Section 16 Planning Application for Proposed Minor Relaxation of Gross Floor Area and Building Height Restrictions for Permitted Office Use and Other Permitted Uses in “Commercial (7)” Zone bounded by King’s Road and Taikoo Shing Road, Quarry Bay (Application No. A/H21/160)

Departmental comments were received via District Planning Office / Hong Kong, Planning Department in March 2026. In response to the departmental comments and public comments received, the Applicants hereby submit a responses-to-comments table with the following attachments for the Board’s consideration:-

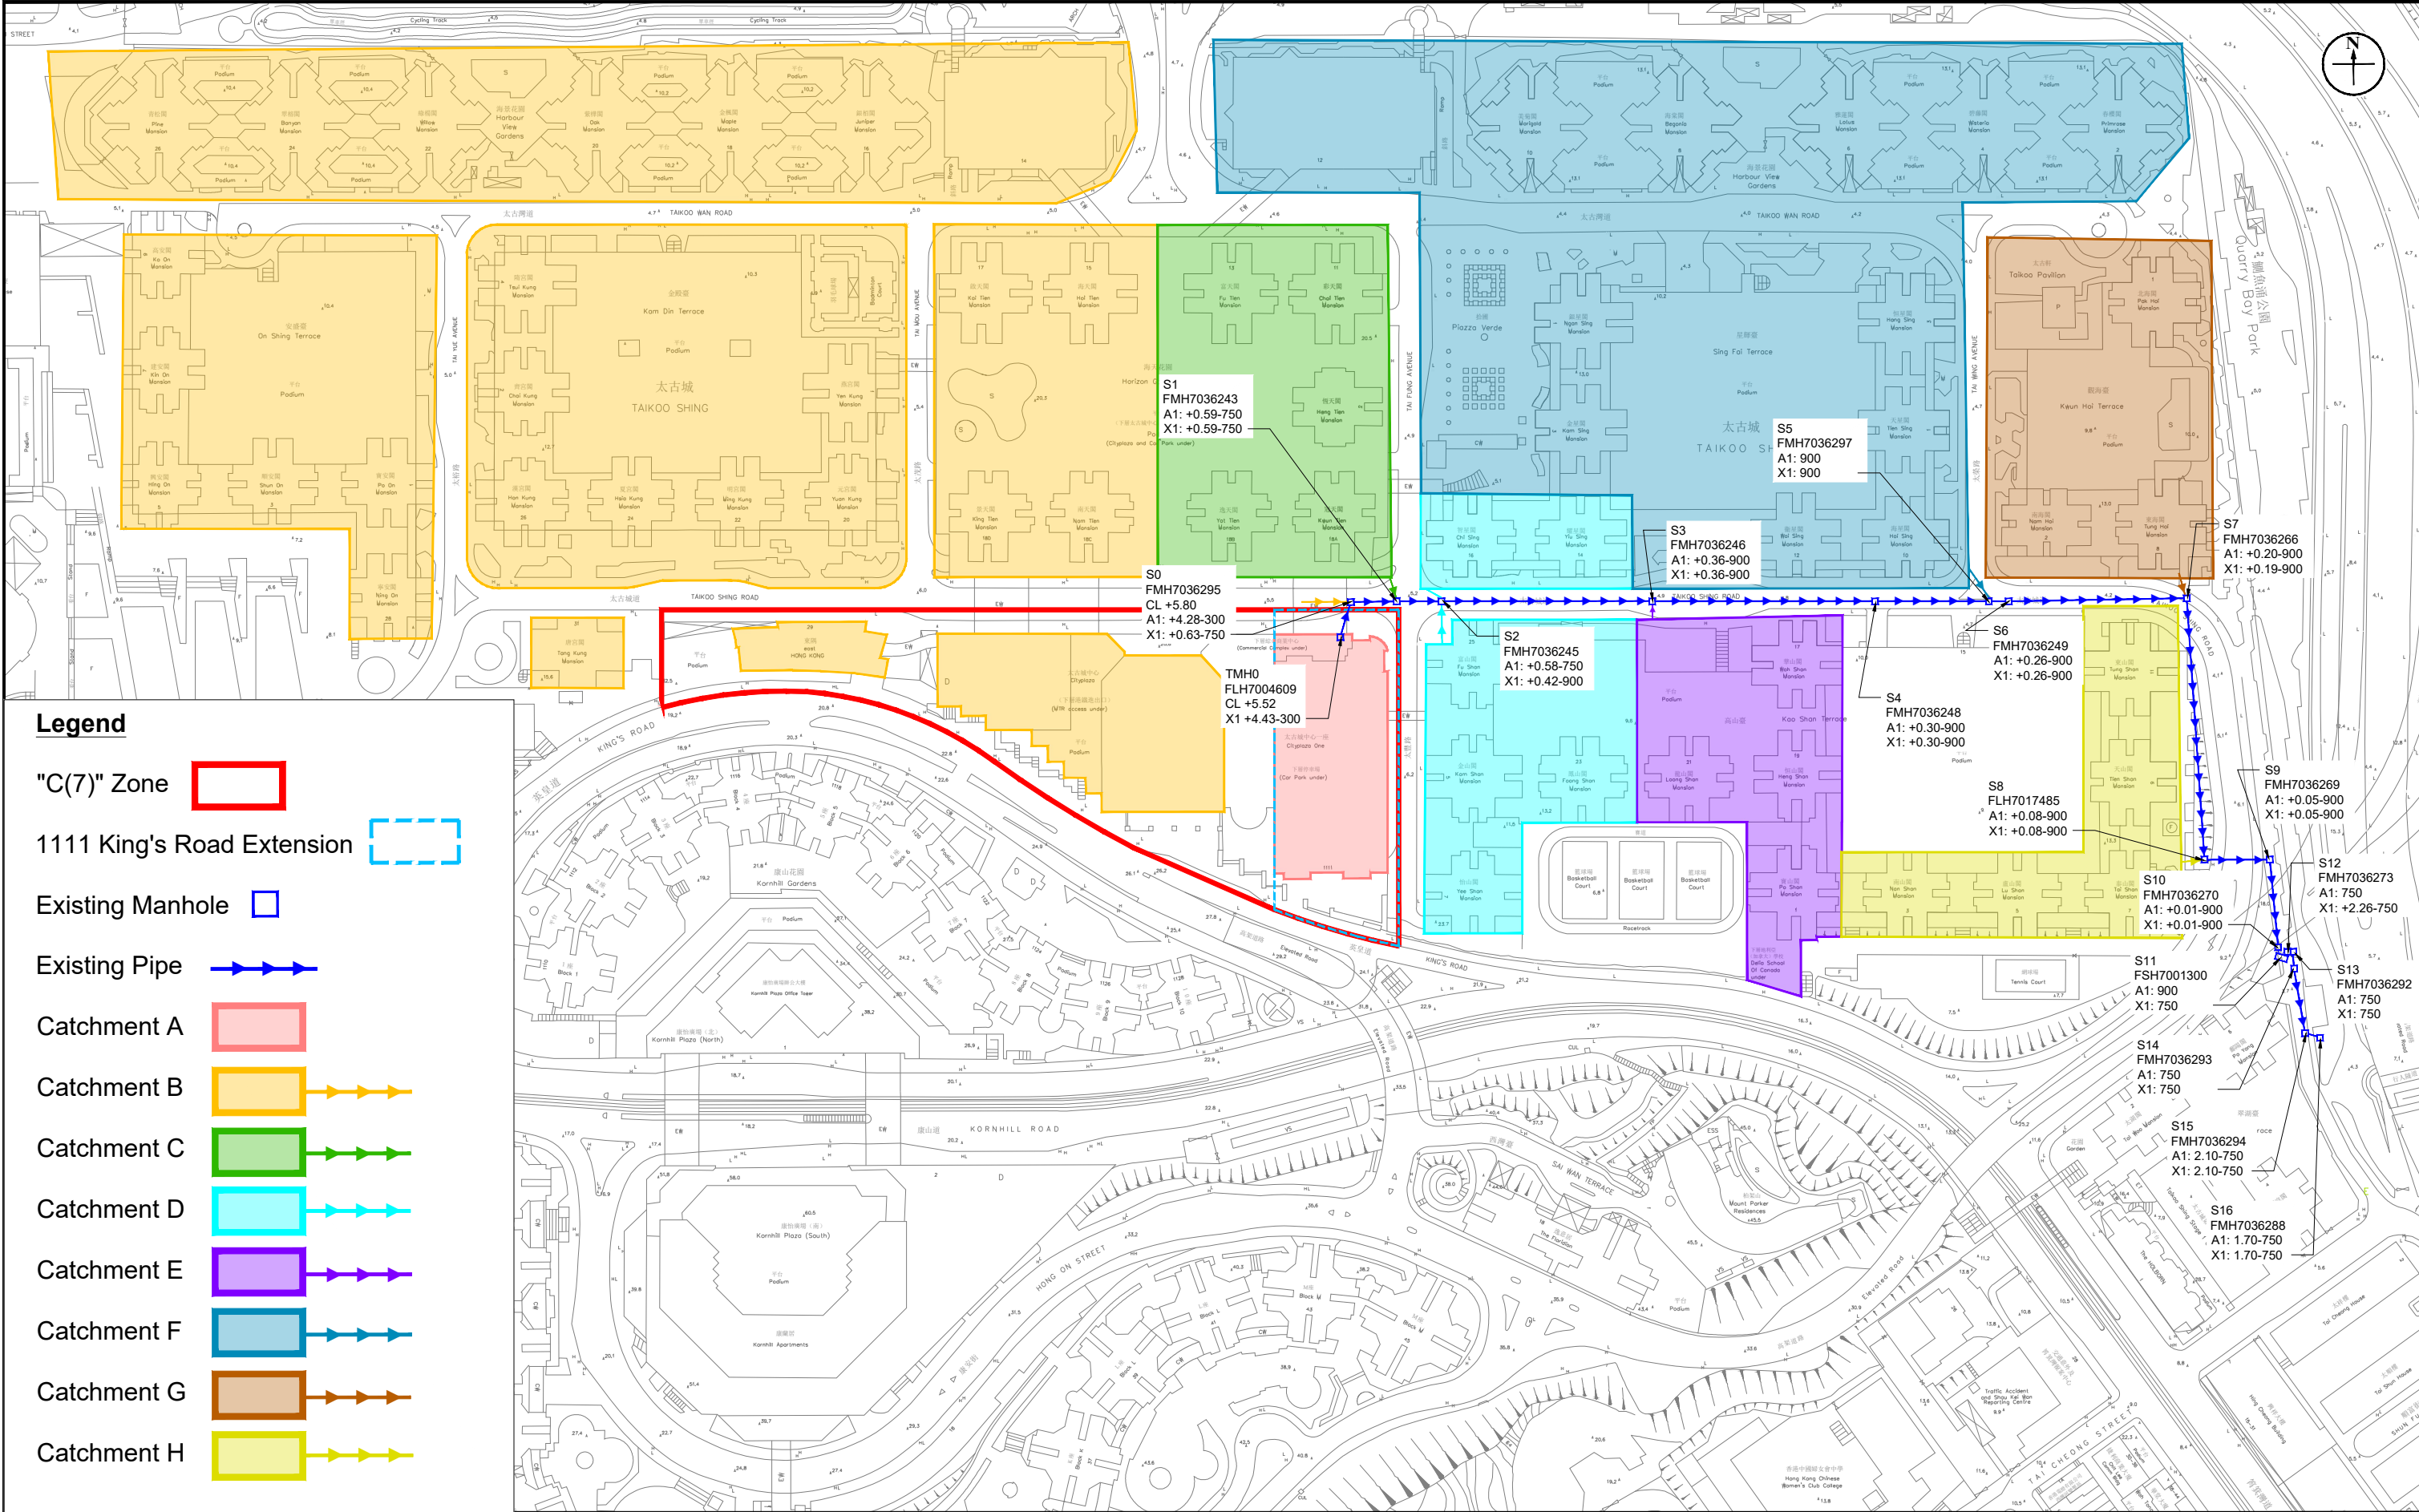
4.7	Please align the building names under different sections in the submission to avoid confusion e.g. Cityplaza Three in Figure 2.2 and 14 Taikoo Wan Road in Table 3 of Appendix 2.1.	The basemap shown in Figure 2.2 has been updated. Please refer to the revised SIA under Attachment 1 .

Title: Proposed Upgrading Sewerage System

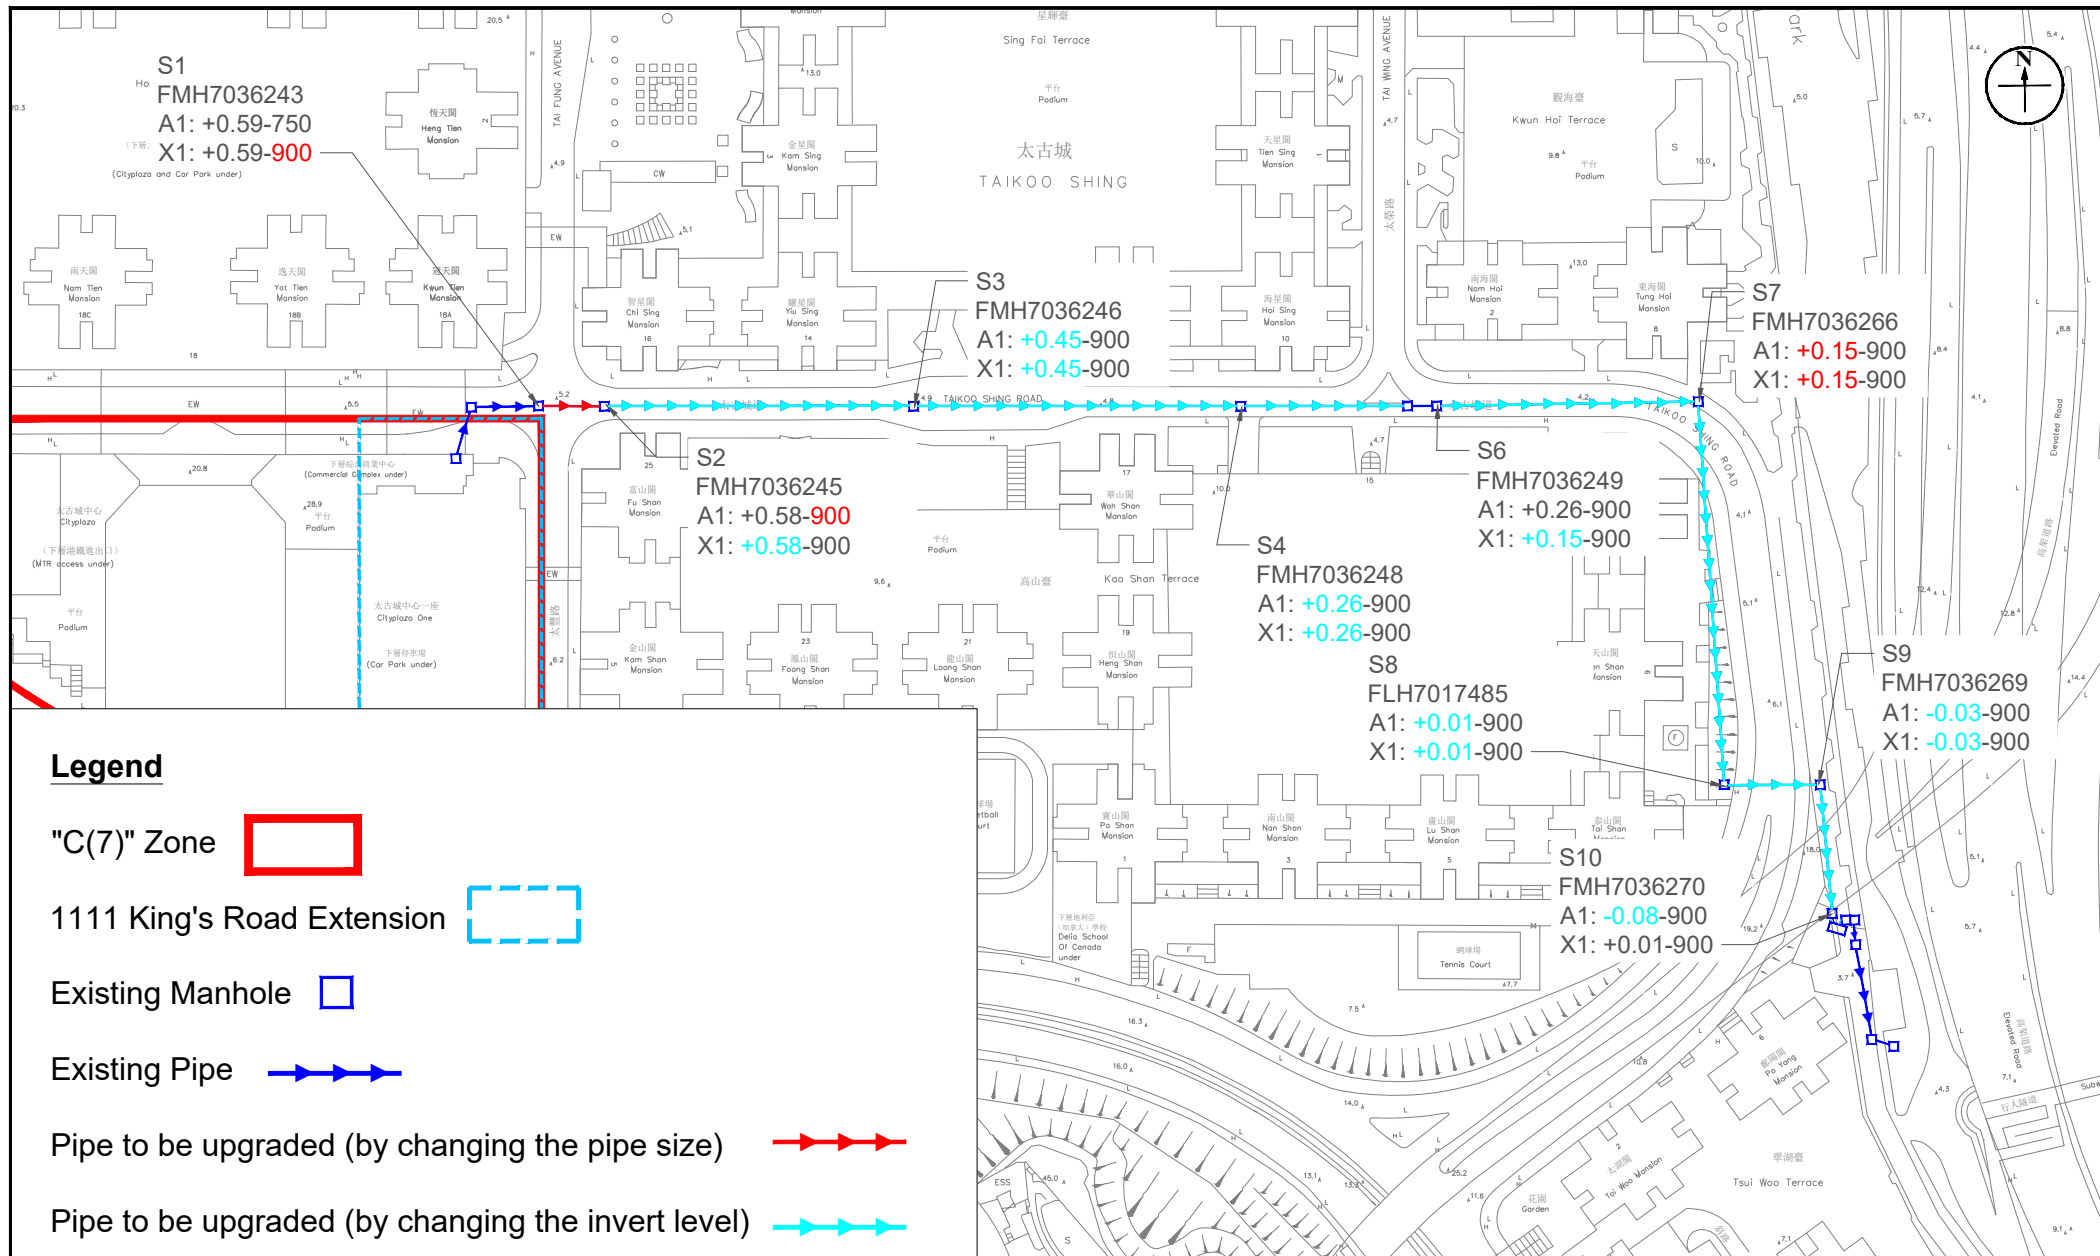
2.5.3 Upgrading works on the sewers (FMH7036243 to FMH7036248 and FMH7036249 to FMH7036270) by the project proponent are required. About 355m of sewers required upgrading works. The details of the proposed upgrading sewers can be referred to **Table 13 of Appendix 2.1** and **Figure 2.3**.

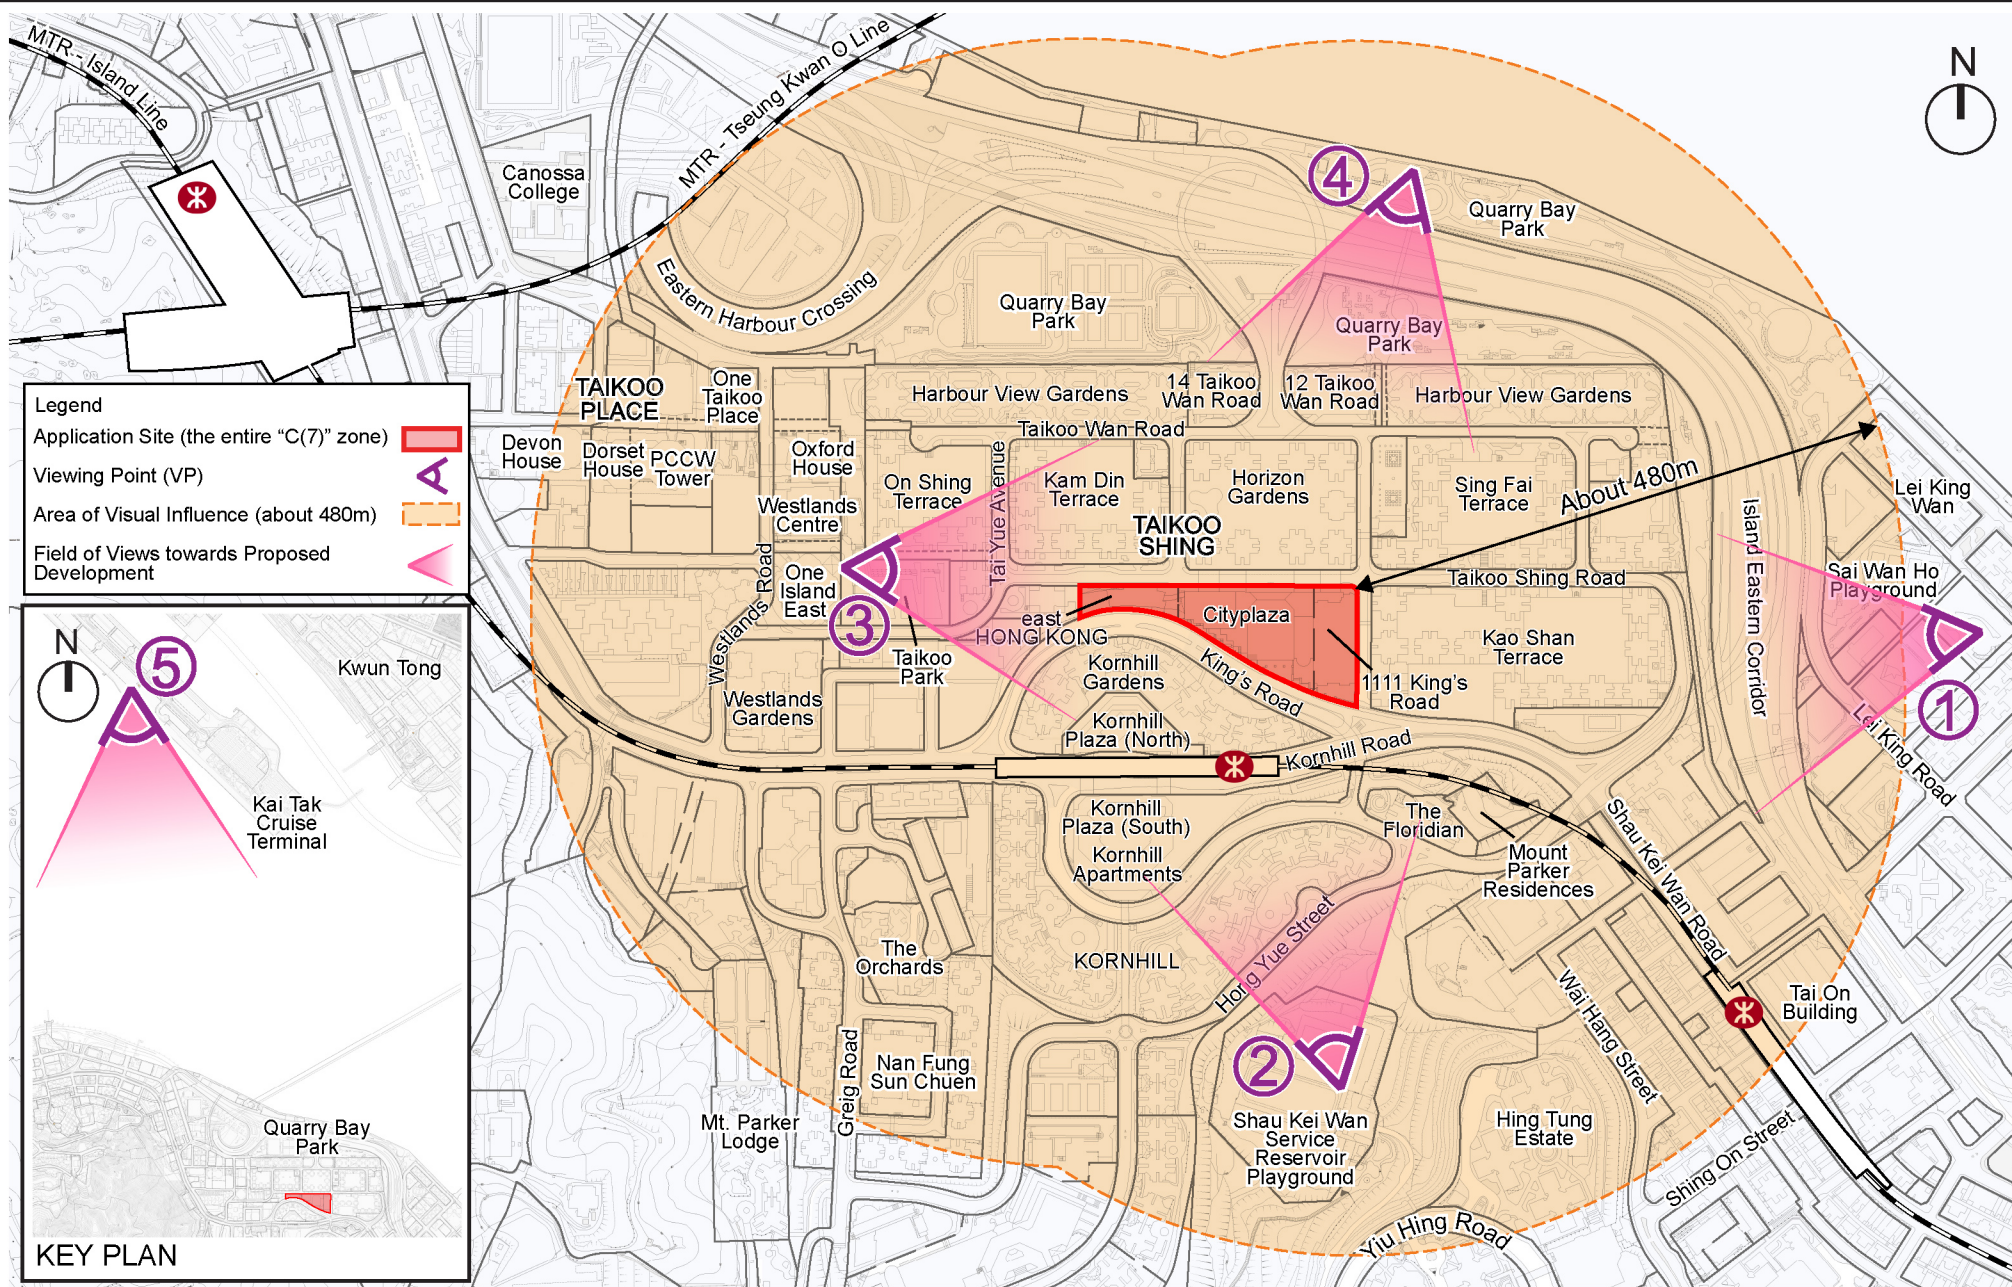
6.	Comments from Urban Design Section, Planning Department	
	<u>Visual Impact Assessment (VIA)</u>	
6.1	Visual envelope has not been included in the VIA in accordance with TPB PG-No. 41A.	Figure 3.1 has been revised with field of views towards the Proposed Development incorporated to indicate the visual envelope. Please refer to the replacement pages of the VIA under Attachment 2 .

6.2	Figure 3.1 – the dotted line of the “area of visual influence” does not match with the orange-shaded area.	Figure 3.1 has been rectified, please refer to the replacement pages of the VIA under Attachment 2 .

VP 5 – Waterfront Promenade at Kai Tak Development (Photomontage in **Figure 4.5**)

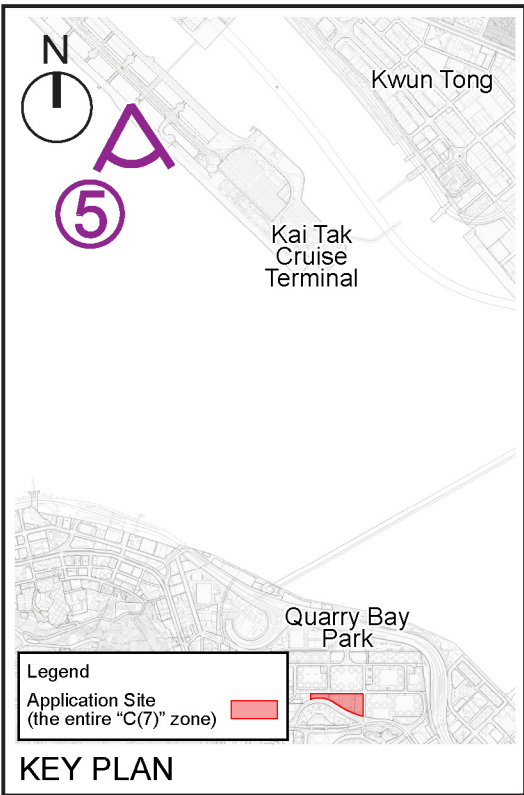
6.3	VP5 – the panorama photo of SVP3 Waterfront Promenade at Kai Tak Development (downloadable on PlanD's website at https://www.pland.gov.hk/file/resources/strategic_vp/image/VP3_photo2.jpg) viewing towards eastern HK Island should be used for assessment. Given that the waterfront promenade is popular and the users are mainly recreational users who enjoy the panoramic view of Victoria Harbour, the sensitivity of public viewers from SVP3 is high.	Figure 4.5 and relevant paragraphs in the VIA have been updated accordingly, please refer to the replacement pages of the VIA under Attachment 2 .
